DEVELOPMENT REVIEW BOARD
SUPPLEMENTAL SUBMITTAL

PROJECT NO. PR-2021-006070

Re: Westpointe40 North Site Plan DRB Comment Responses (PR-2021-006070)

This memo outlines the responses and changes made to the site plan for the proposed 150K spec industrial building at Westpointe40 based on the comments received and reviewed at the December 1, 2021 DRB meeting. The comments are numbered and followed by the response in italics.

TITAN 150K SPEC BUILDING ALBUQUERQUE, NM	DRAWN BY pm
	CONCEPTUAL MASTER UTILITY PLAN	DATE 12-6-21
	5571 MIDWAY PARK PL NE ALBUQUERQUE, NEW MEXICO 87109 (505) 858-3100 www.tierrawestllc.com	DRAWING 2020088-150K-MU.DWG
RONALD R. BOHANNAN P.E. #7868	SHEET # MU-1	JOB # 2020088

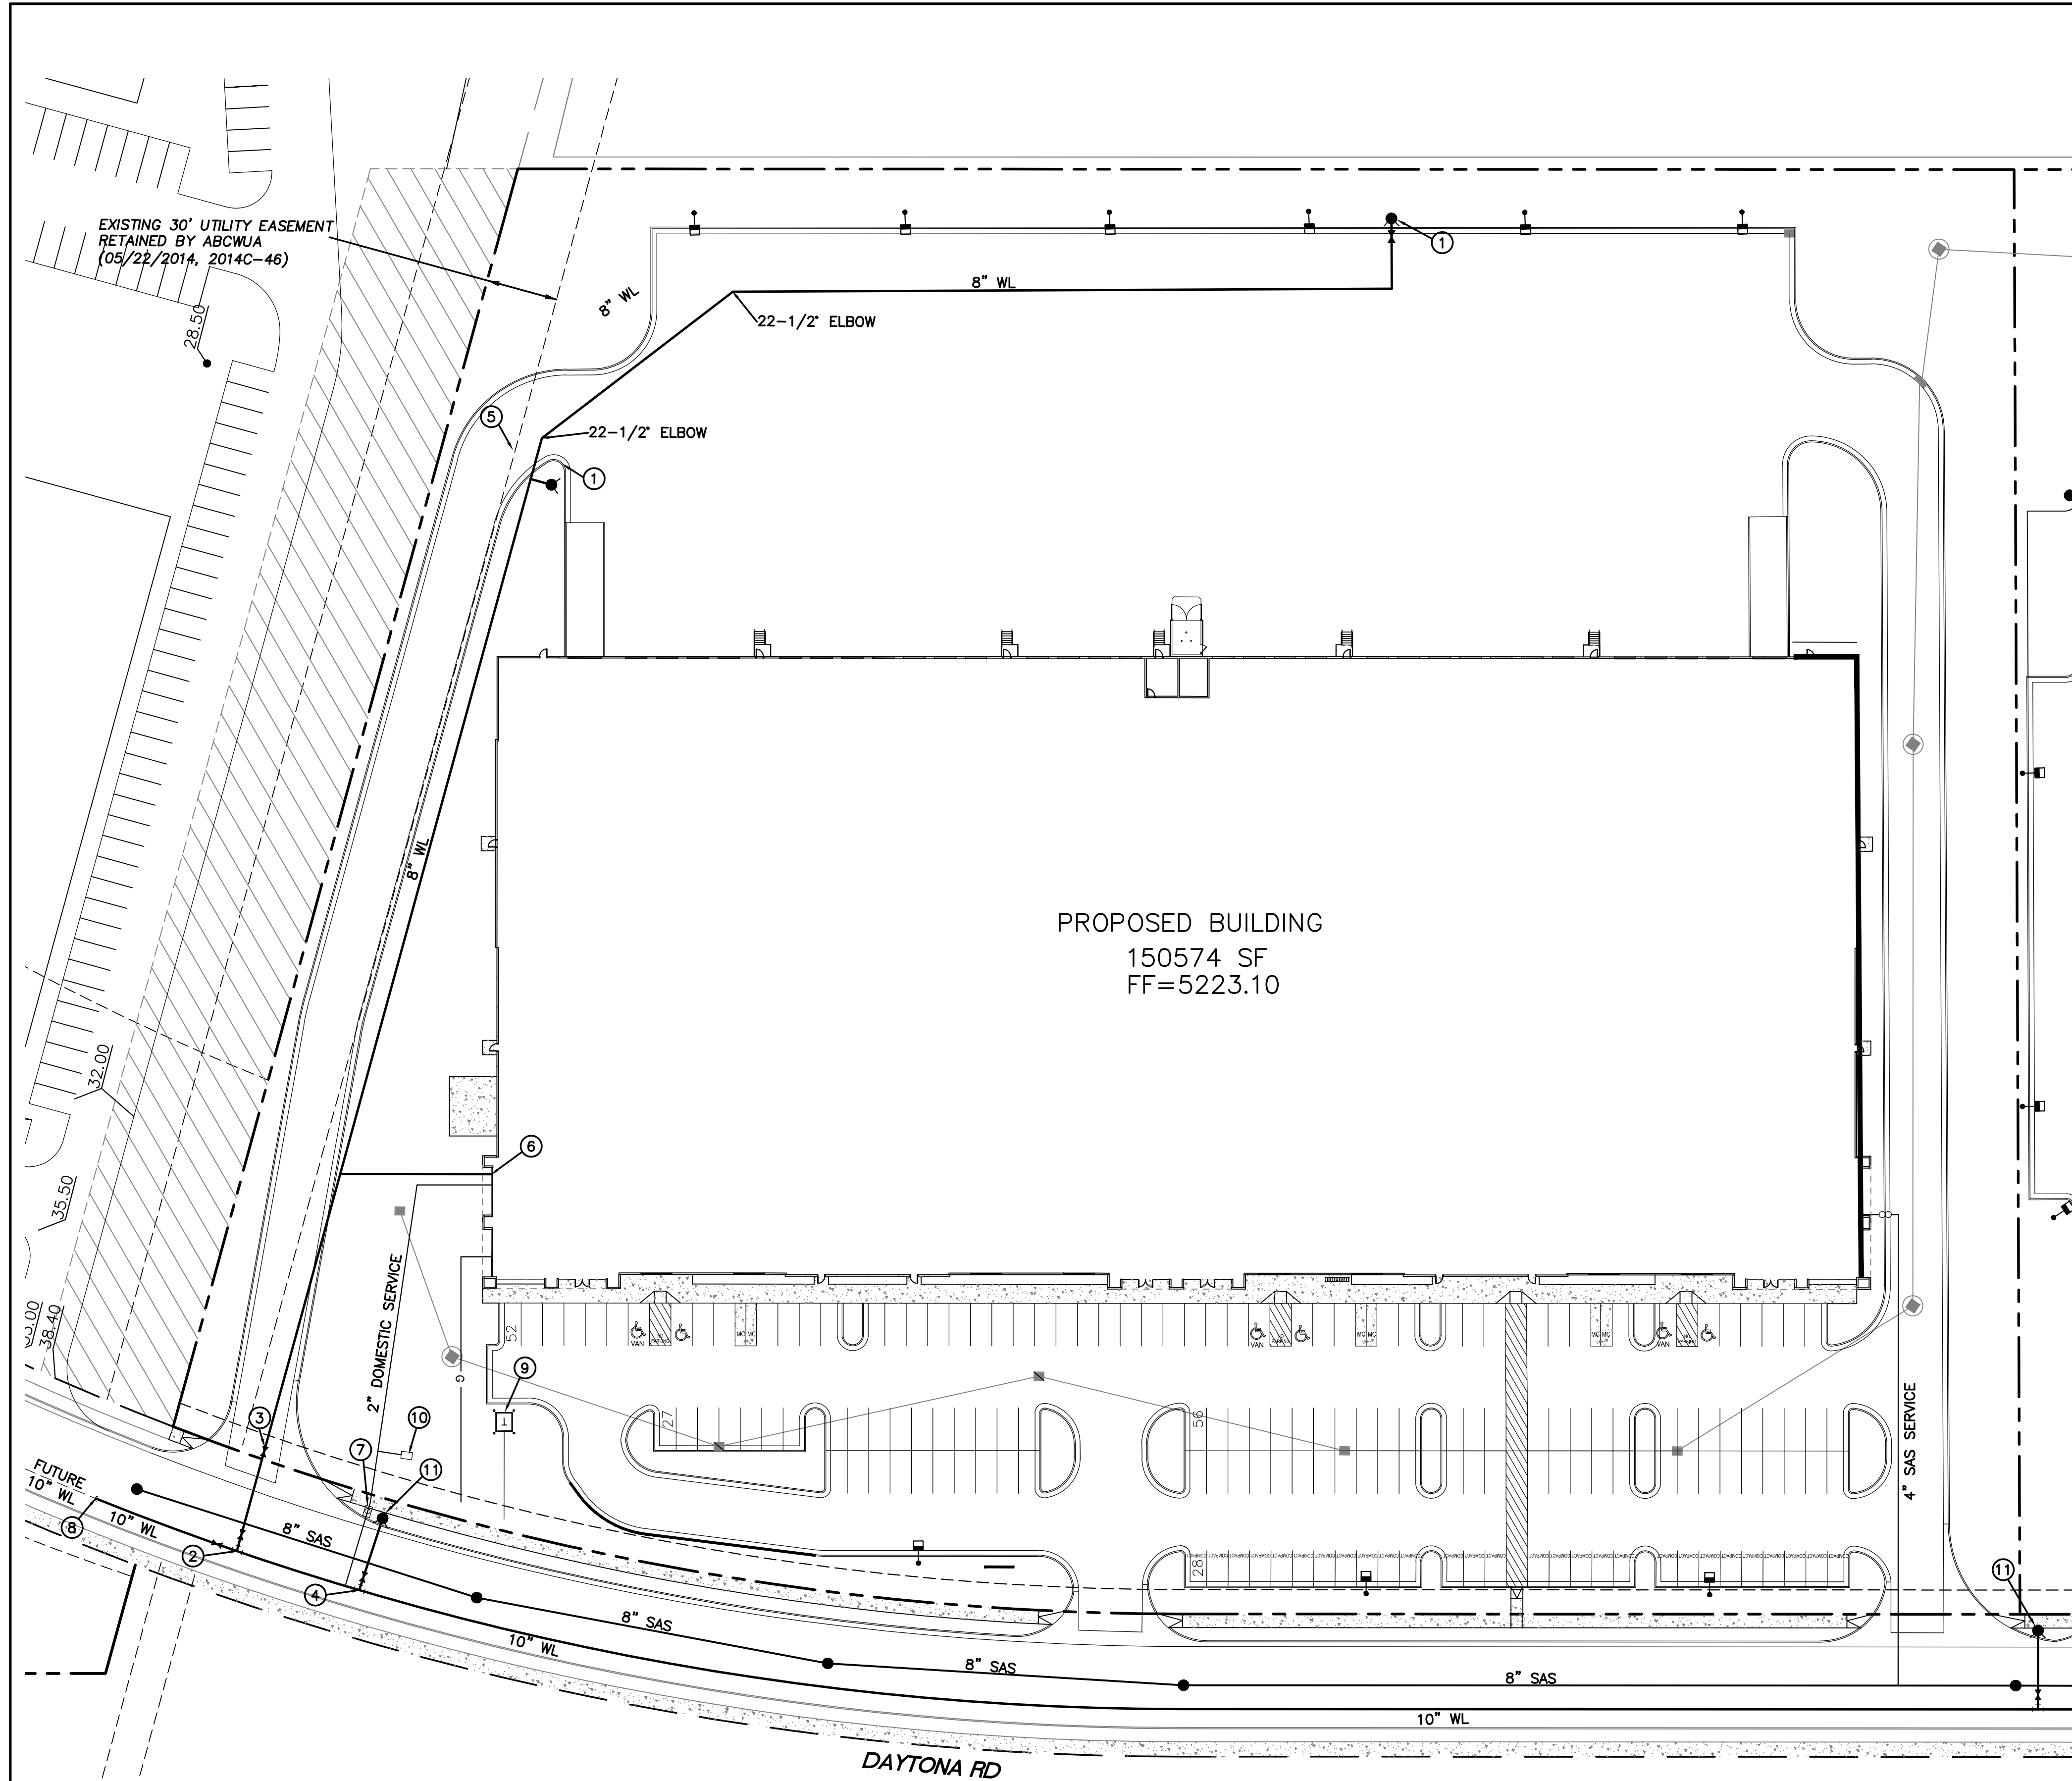
2. This project is within the adopted service area.
3. Pro rata is not owed for this property.
4. Utility Plan:
 - a. The meters need to be at the right-of-way line. The WUA will not maintain a line onsite to shorten the private water line lengths.

- b. The proposed public hydrant needs to be within the right-of-way or within a public water easement. Please revise accordingly.
 - c. The required water main has been revised to a ten-inch. Please revise the call-out to be consistent with this requirement.

- d. One of the four required hydrants is to be on the parcel to the south. Please provide some sort of agreement or easement that will enable this site to utilize that offsite hydrant.

- *An updated utility plan has been provided with the supplemental submittal.*
5. Infrastructure List:
 - a. The improvements required in the Availability Statement shall be incorporated into the infrastructure list.
